PRODUCT/PROCESS CHANGE NOTICE (PCN)

ATTACHMENT I - PCN #: TB0711-02

PCN Type: Packing Material

Detail of Change: This notification is to advise our customers that IDT has qualified new shipping trays for 14 mm x 14 mm PQFP 52L and 64L products.

Existing Shipping Tray

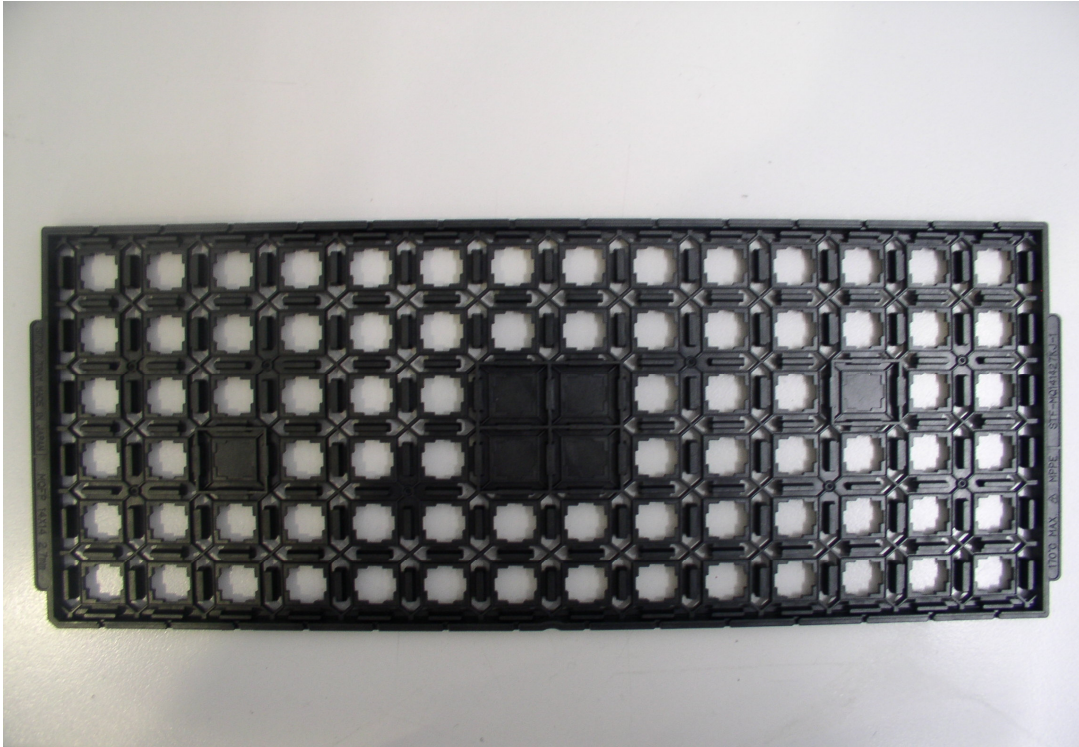
There is no change to the number of units per tray and tray dimensions but changes to the tray withstand temperature.

Description	Existing Shipping Tray	New Shipping Tray
Supplier	Shinon	NK Tech
Supplier Part Number	STF-MQ141427LD-1	TMHT-061402-02
IDT Part Number	P7-148-000	P7-229-000
Tray Matrix	6 X 14	6 X 14
Qty per Tray	84 units	84 units
Rating Temperature	150°C	135°C
Tray Material	PPE + CF	PPE + CF
Pocket Size (WxL)	13.83 X 13.83 +/- 0.13 mm	13.92 X 13.92 +/- 0.07 mm
Tray Drawing Number	MSC-1717	MSC-5758
